**Subject: Olin Chemical Superfund Site, Wilmington, Massachusetts  
Response to USEPA Comments Dated September 30, 2014  
OU1 /OU2 RI Sections 1-5 Including Stakeholder Comments**

## USEPA COMMENTS

**Arsenic Log-transformed – Surface Soil (Olin Data) (Normal-One Population)**

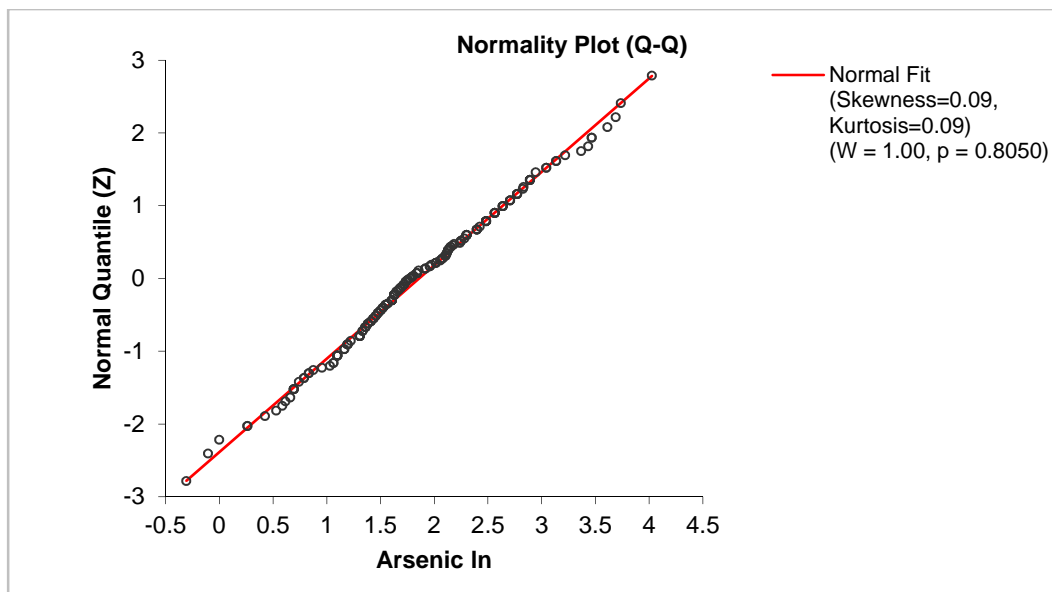
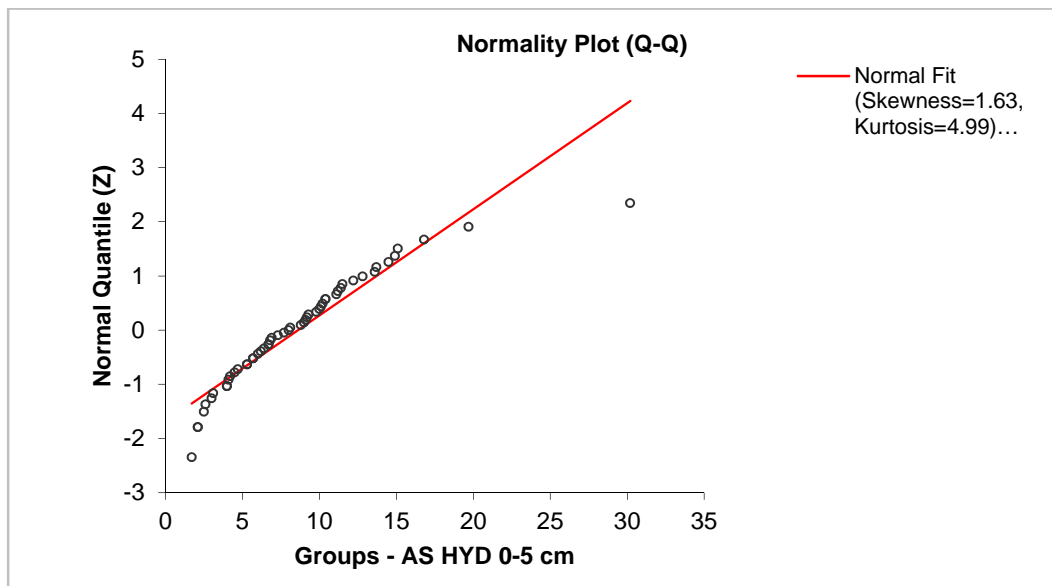
*The following graphs represent the distribution of arsenic in soil for OU1 with the two outlier areas (Pan AM railroad bed and EA5) removed from the sample population*

*and of USGS Soil Background Data for Maine and New Hampshire. Both data sets are Log-transformed with normal distributions that represent a single sample population that is background.*

*Review of the graphs and data indicate arsenic concentrations are consistent in OU1 surface soils among all of the exposure areas and represent a single sample population. This would indicate a background data set and does not indicate a release of arsenic.*

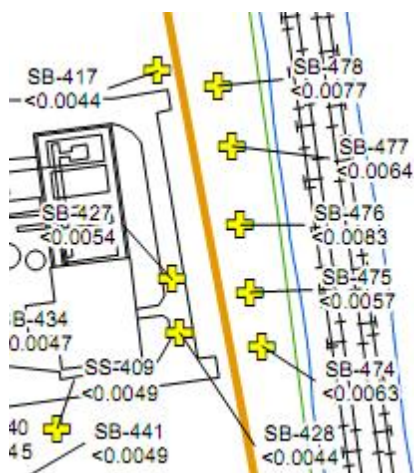
- a. In Figure 4.1-12, TMP exceedances of the calculated industrial RSL were detected in SB-475 through SB-477. Given that these concentrations are at the property boundary, it

is possible for additional soil contamination to be located across the railroad tracks to the east. Therefore, TMP has not been fully delineated in this area.

- b. In Figure 4.1-13, TMP exceedances of the calculated industrial RSL were detected in SB-427 and SB-476 through SB-478. No samples are located to the north or east, suggesting that TMP has not been delineated in this area.

**USEPA Reply:** On Figure 4.1-13 the northern most sample exceeds the calculated industrial RSL. Because the figures demonstrate contamination above screening levels, with no apparent closure to the extent of contamination, the text needs to explain why this is not an issue. EPA understands that the tracks limit sampling to the east. An explanation is needed for **why** sampling to the north has not occurred.
